Ref: Pearson-10M #61

The toe rail area of the above referenced Pearson-10M needs additional reinforcing laminations.

PEARSON 10M
TOE RAIL LAYOUT

PEARSON 10M
AREAS TO BE FIBERGLASSED

DIAGRAM 1
5-5-75

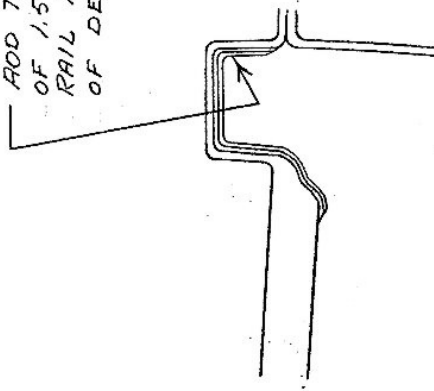
The specific location is from genoa track to genoa track around the transom. This also includes the area under the genoa tracks. Any visible signs of weakness would be slight cracks parallel to, and on the inboard edge of the toe rail. In addition, the genoa track may show signs of lifting at the bolts.

1. Remove genoa track.
2. Lay up two strips of 1½ ounce or heavier mat per Diagram #1.
3. Make the layup wherever the underside of the toe rail is accessible, per Diagram #2.

ADD TWO (2) ADDITIONAL LAYERS
OF 1.5 OZ MAT UNDER THE TOE
RAIL AND LAPPING UNDER SIDE
OF DECK AS SHOWN ON SHEET 2.

DIAGRAM 2
5-5-75

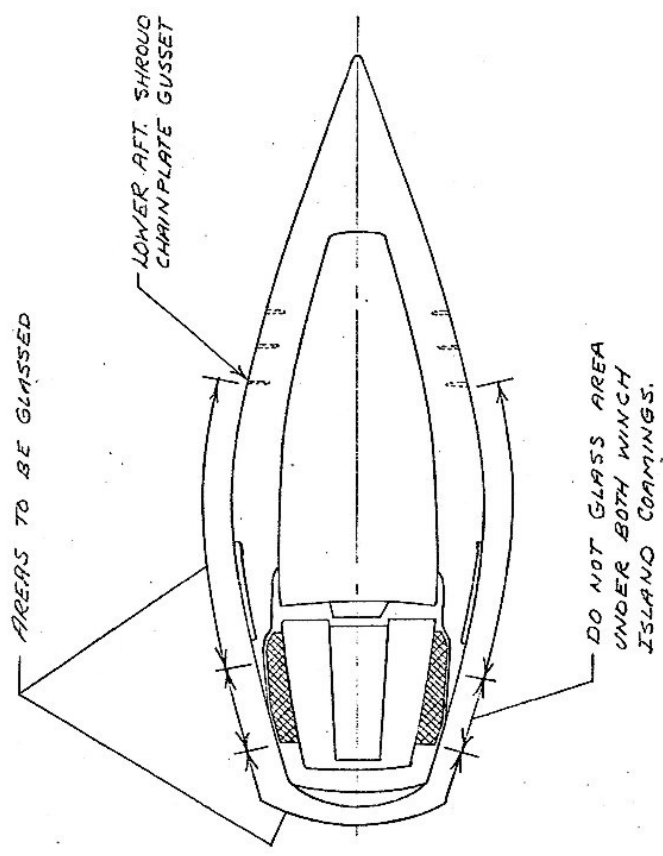
ADD TWO (2) ADDITIONAL
LAYERS OF 1.5 OZ MAT
INSIDE OF EXTERIOR PANEL
COAMING SIDES ALL AROUND,
INCLUDING TRANSOM AS
SHOWN ON SHEET 2.
THE AREA UNDER THE
WINCH ISLANDS ARE TO BE
EXCLUDED.

DO NOT GLASS AREA
UNDER BOTH WINCH
ISLAND COAMINGS.
